## Asbury Chapel Subdivision Sketch Plan

### PART 1: PROJECT SUMMARY

### PART 2: SITE PLAN DESCRIPTION AND ISSUES

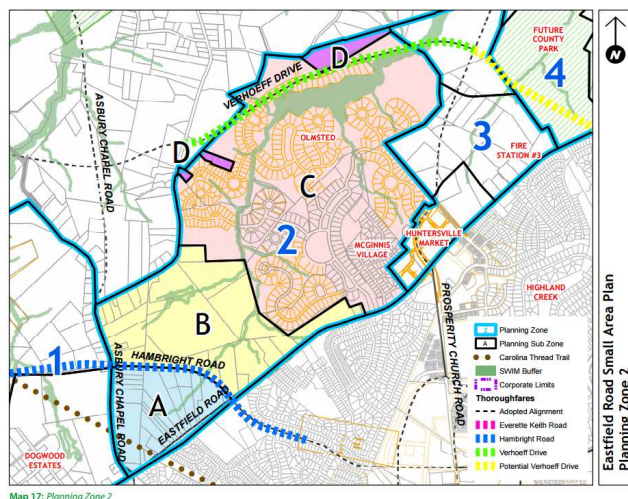
**STAFF COMMENT:** The proposed development has two entrances from Asbury Chapel Road. Internal to the subdivision, on the southern and eastern property lines a stub street will be constructed with right of way connecting to the adjoining property line.

Map 17: Planning Zone 2  
Eastfield Road Small Area Plan | Adopted by Town Board of Commissioners on January 6, 2014

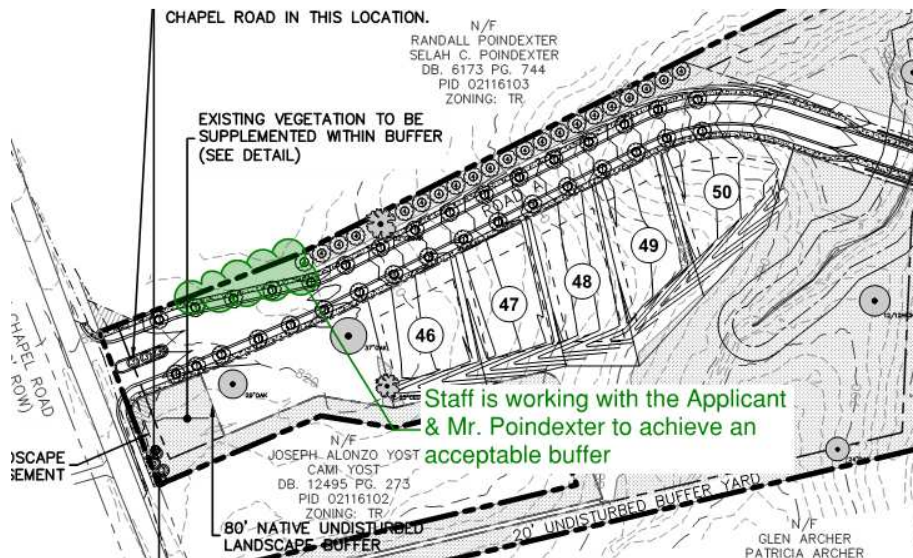
The proposed development is in keeping with the density in the Eastfield Road Small Area Plan and other major subdivisions in this area (Zone 2). Olmsted .95 units to the acre is currently zoned Transitional (TR) and Rural (R).
